Work Order ID 99473

Item Name: Crosstube Turning Detail

DART AEROSPACE LTD		Work Order:	99473
Description: Crosstube Assembly		Part Number:	D407-667-145
Inspection Dwg: D407-667-145 Rev: C		Page: 1 of 2

DRAWING NO. D407-667-145	TITLE CROSSTUBE ASS'Y (407 HIGH FWD)	REV. C	DART AEROSPACE LTD ENGINEERING ORDER		D.E.O. NO. D407-667-145-C-1	SHEET NO. SHEET 1 OF 1	SCALE NTS
DRAWN 97	CHECKED ASS	MFG. APPR. 123	APPROVED MD		DE APPR. H		
DATE 11.07.15	DATE 11.07.22	DATE 11.07.22	DATE 11/07/22		DATE 11.07.21

DETAIL P
BONDING STRAP INSTALLATION 2 PL

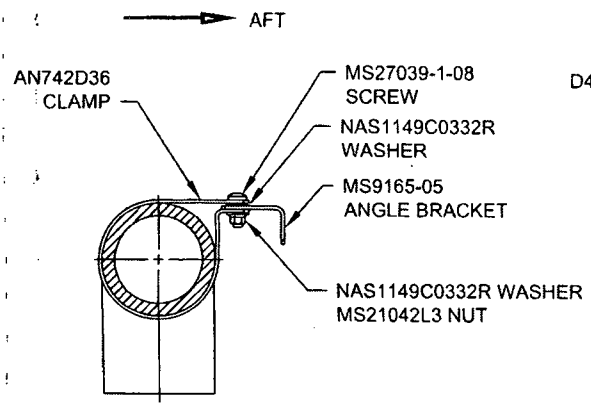
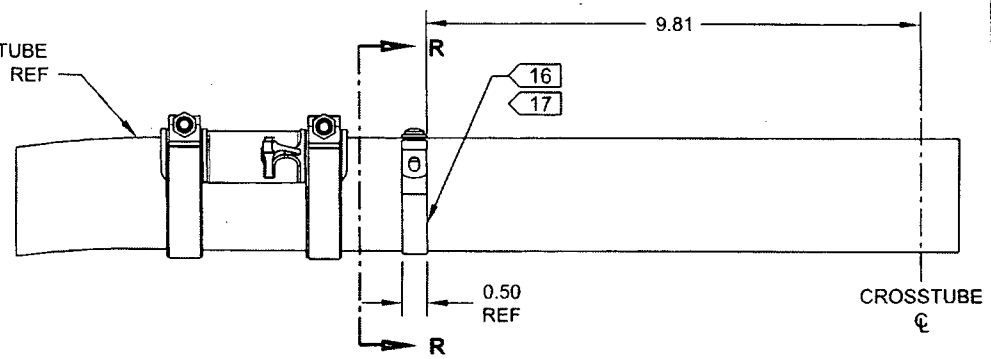
ADD ELECTRICAL GROUNDING STRAP

ITEM	QTY	PART NUMBER	DESCRIPTION
1	X	D407-667-145	CROSSTUBE ASSEMBLY (407 HIGH FWD)
10	2	AN742D36	CLAMP
11	2	MS9165-05	ANGLE BRACKET
12	2	MS21042L3	NUT (OR MS21042-3)
13	2	MS27039-1-08	SCREW
14	4	NAS1149C0332R	WASHER (OR AN960C10L)

- 16) MASK AREA UNDER CLAMP PRIOR TO PAINTING
- 17) SEAL EDGES WHERE AN742D36 CLAMP MEETS WITH THE CROSSTUBE USING SIKAFLEX-241/-291 OR MIL-S-8802 CLASS B2 OR PROSEAL 890 SEALANT
- 18) PERFORM RESISTANCE CHECK TO ENSURE MAX RESISTANCE IS 10 MILLIOHMS
